- 11. Smurfy Acres 2022 Replat; KPB File 2022-080  
Geovera, LLC / Glanville  
Diamond Ridge Area / Kachemak Bay APC**

ITEM 11 - SMURFY ACRES 2022 REPLAT

KPB File No.	2022-080
Plat Committee Meeting:	July 18, 2022
Applicant / Owner:	John and Laurie Glanville of Homer, AK
Surveyor:	Stephen Smith / Geovera LLC
General Location:	Sterling Highway, Diamond Ridge Road, Diamond Ridge / Kachemak APC

STAFF REPORT

## SMURFY ACRES 2022 REPLAT

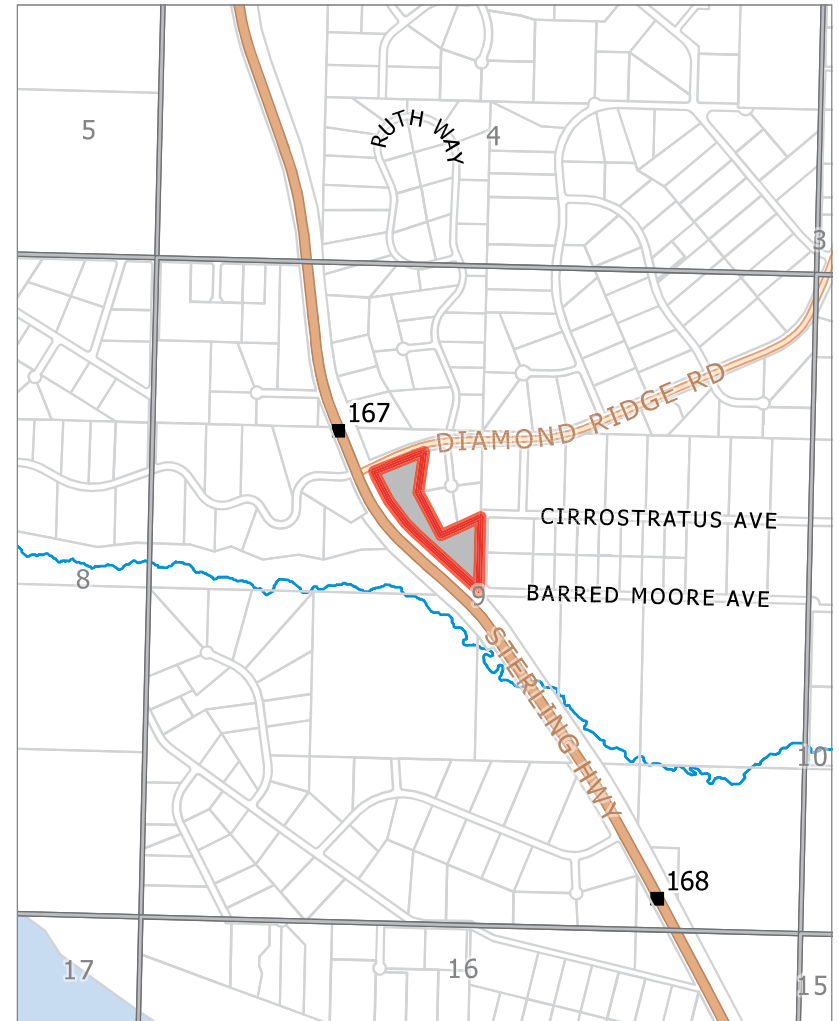
There currently appear to be a developed access from Diamond Ridge Road to proposed Lot 1-B. An access is also located from the Sterling Highway near the proposed lot line. This access appears to contain developed access that will continue to proposed Lot 1-A and also provides access to proposed Lot 1-B. The location of the driveway is not shown on the plat so the true location is not known. Per KPB GIS data and imagery, it appears that the access may also cross into Lot 5, HM 85-30, that is adjacent to the property. Records indicate the lot is the same owner of the preliminary plat. As both lots have additional dedicated access the KPB Code requirements have been met. However, if the ownership of any of the lots change, the existing access may no longer be able to be used unless access or driveway easements are granted. **Staff recommends** if the owners wish to address the existing access, it should be depicted on the final plat and appropriate plat notes shall be added depending on the owners plans on moving forward.

**Site Investigation:** There are some low wet areas present and are depicted on the plat. **Staff recommends the wetland depiction remain on the final and a wetland determination plat note be added.**

Some slopes exceed the 20 percent slope and are depicted with a hatching. **Staff recommends the hatching remain on the final plat if it does not interfere with other required information.**

Using KPB GIS imager, it appears that some improvements may be close to property lines along the Sterling Highway. Per Smurfy Acres, HM 85-30, a 20 foot setback was placed along all rights-of-way. This would include along the Sterling Highway and Diamond Ridge Road. A right-of-way project for the Sterling Highway was done in 2018 per plat note 7. If that project changed the right-of-way width in this area the building may be excluded from the 20 foot setback. **Staff recommends during the field survey determine if any permanent structures are within the 20 foot setback, if there are it will need to be determined if they will predate any existing setbacks or subject to new setbacks, if they are determined to be exempt, the buildings will need to be shown with the correct plat notes added.**

The dedication of Aviation Way occurred after the creation of the parent lot within this preliminary plat. A setback along Aviation Way has not been created. **Staff recommends the 20 foot building setback be put into place, if any existing permanent structures are in place they will require depiction and plat notes stating their exempt status must be added.**

Per plat note 5, this plat will be granting utility easements within 10 feet of all rights-of-way. **Staff recommends the plat note be reworded to closer match current code and to state that the easements are being granted by this plat and that the easements be depicted if possible.**

- G. The status of adjacent lands within 100 feet of the proposed subdivision boundary or the land status across from any dedicated rights-of-way that adjoin the propose subdivision boundary, including names of subdivisions, lot lines, block numbers, lot numbers, rights-of-way; or an indication that the adjacent land is not subdivided;
- Staff recommendation:** *Provide a width label for Glanville Circle. Provide a label for Lot 32 HM 81-08, located to the northeast. The deed parcel to the north has a preliminary design approved. A final has been submitted but not recorded at time of review. Prior to printing the mylar, verify the status of the lot to the north and update depiction and status labels as needed. Show separate lot distances along the line on Sterling Highway.*

**Staff recommendation:** *A setback should be put into place along Aviation Way.*

- Per the Certificate to Plat, the property is subject to reservation of easement for highway purposes. Provide a plat note that states the different PLOs and the dates.
- Any person developing the property is responsible for obtaining all required local, state, and federal permits, including a U.S. Army Corps of Engineers wetland determination if applicable.
- Any required notes for improvements within new setbacks or utility easements.

Update plat note 5, "The front 10 feet adjoining all rights-of-way is granted by this plat as a utility easement. No permanent...."
